Piper Aircraft, Inc.  
 2926 Piper Drive  
 Vero Beach, Florida, U.S.A. 32960

# SERVICE NO. 1251 BULLETIN

Date: April 10, 2013 (S)

**STABILATOR TRIM BARREL INSPECTION**

Figure 1

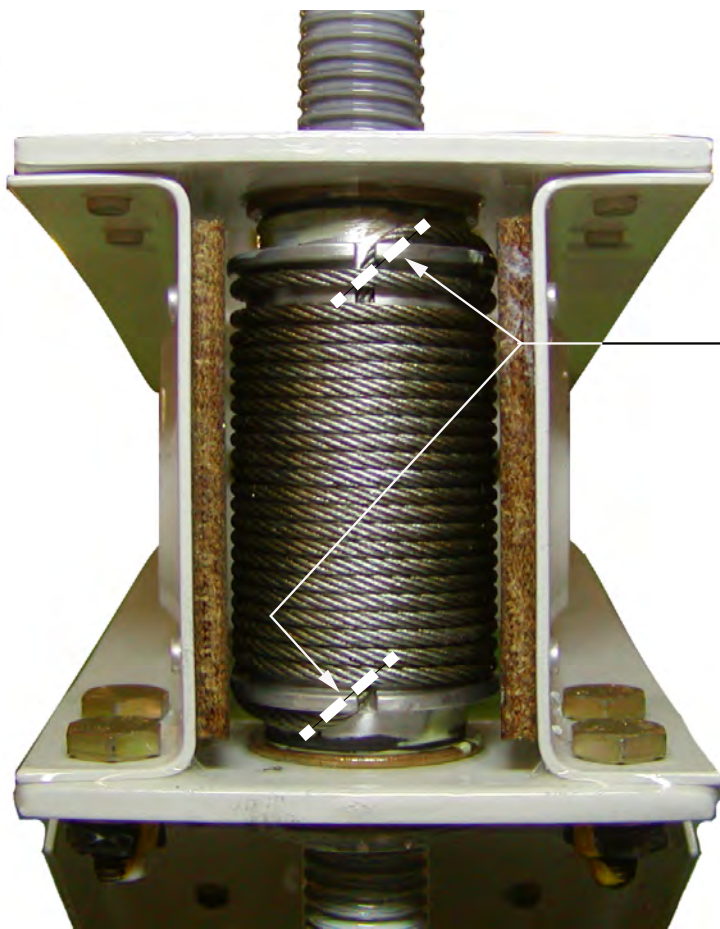
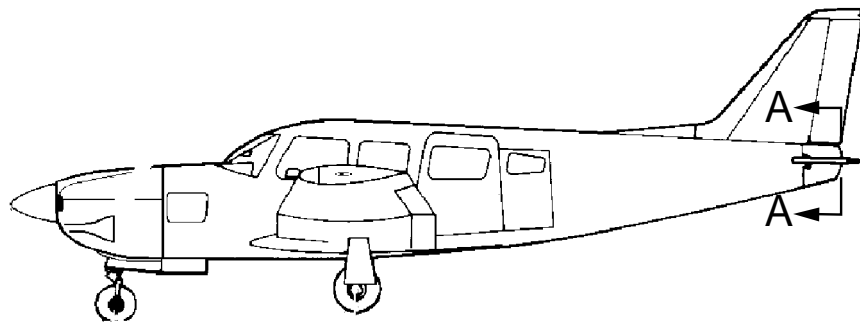
2. Identify the stabilator trim barrel and examine the routing of the stabilator trim cable at the locations shown in Figure 1. Additionally, compare the installed trim barrel against the CORRECT and INCORRECT trim barrel details shown in Figure 2.

- If the geometry of the stabilator trim barrel matches the illustrations marked "CORRECT" in Figure 2, then the stabilator trim barrel is acceptable for continued use. Reinstall the tailcone access panel, and proceed to Part IV.
- If the geometry of the stabilator trim barrel matches the illustration marked "INCORRECT" in Figure 2, replacement of the stabilator trim barrel and aft stabilator trim cable is required. Proceed to Part III.

Figure 2

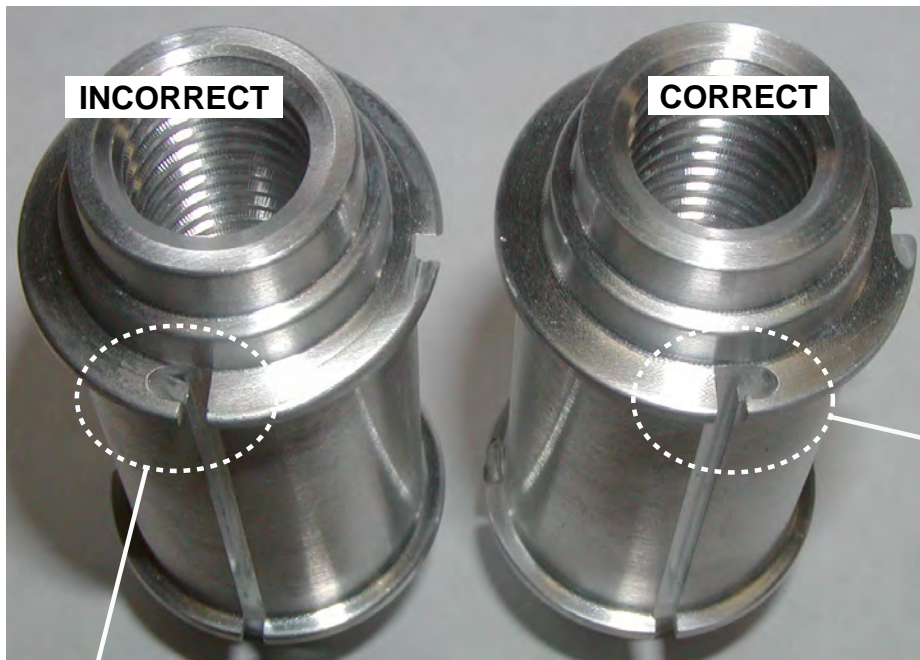
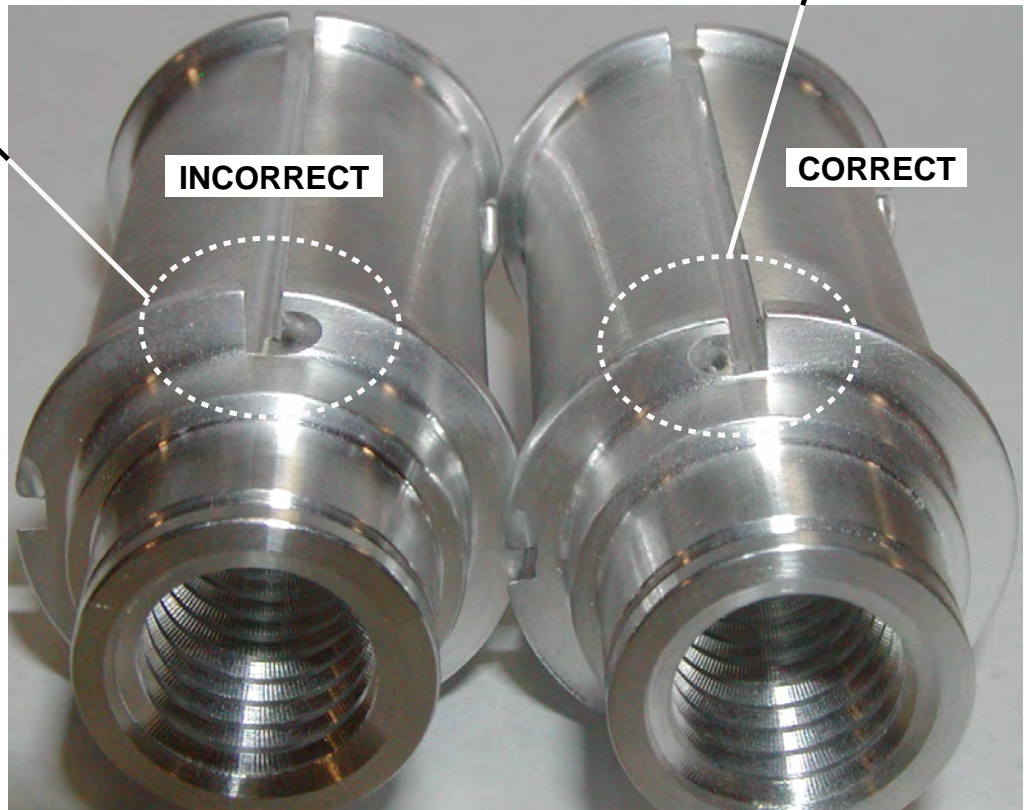
**NOTE:** A correct trim barrel is distinguished by visual examination of the stabilator trim cable at the locations where the cable passes through the slots in the upper and lower flanges of the trim barrel. A correct trim barrel will feature diagonally machined grooves in the flange to accommodate the cable routing. The installed cable is nested into these grooves, reducing cable strain. An incorrect trim barrel will have these diagonally machined grooves located on the opposite side of the slot from the cable routing.

**INCORRECT** geometry of diagonally machined grooves in the stabilator trim barrel flanges.

1. Order replacement stabilator trim barrel, as well as replacement aft stabilator trim cable. Refer to the MATERIAL REQUIRED section of this service bulletin for the appropriate replacement part numbers.
2. Using instructions in the appropriate maintenance manual, remove the incorrectly manufactured stabilator trim barrel and aft stabilator trim cable. Return both parts to Piper for examination.
3. Using instructions in the appropriate maintenance manual, install, rig and adjust the new stabilator trim barrel and aft stabilator trim cable.
4. Reinstall the tailcone access panel, and proceed to Part IV.
